R00DN

RECALL R00DN

ROOF JOINT RIVET INSPECTION AND REPAIR PROCEDURES

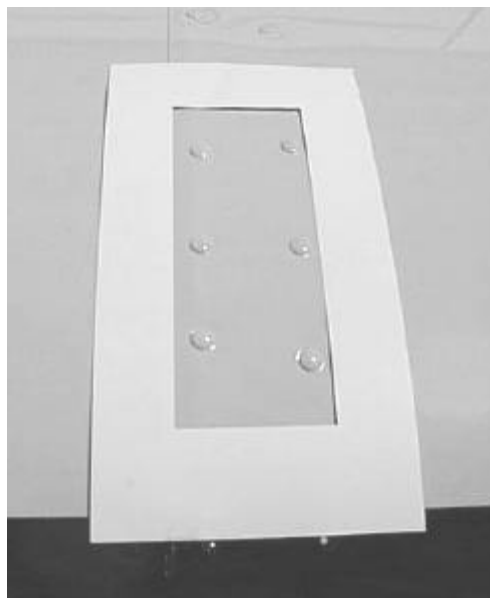
2. Roof panel joints are assembled with two rows of rivets. Each joint must have a minimum of **six** rivets in each eight inch segment. In any area requiring additional rivets, add the rivets to the row with the fewest number of rivets in any given eight inch segment.
3. Place template over joint of adjoining roof panels. Longest section of the template should be positioned parallel to the roof panel joint, with the roof rivets exposed through the opening in the template as shown below.

4. Move template along the roof panel joint across the bus body. As the template is moved, count the rivets that appear in the cutout section of the template. In any given position, a minimum of **six** rivets should be visible within the cutout.

5. If a segment in the roof panel joint contains less than six rivets, additional rivets will need to be added to the joint at this section. **Mark each area that requires additional rivets.**

6. For each additional rivet needed, drill a 13/64" diameter hole through roof panels. Be sure to drill hole in line with existing rivets. **Do not drill through the inner headlining panel.**

7. Install rivet (#1989946) in each drilled hole.
 8. Use touch-up paint to match roof color on rivet heads.
 9. Continue the rivet quantity check and repair across the entire length of the body sheet and on every roof sheet joint on the bus body. Touch up rivet heads with appropriate paint to match roof color.
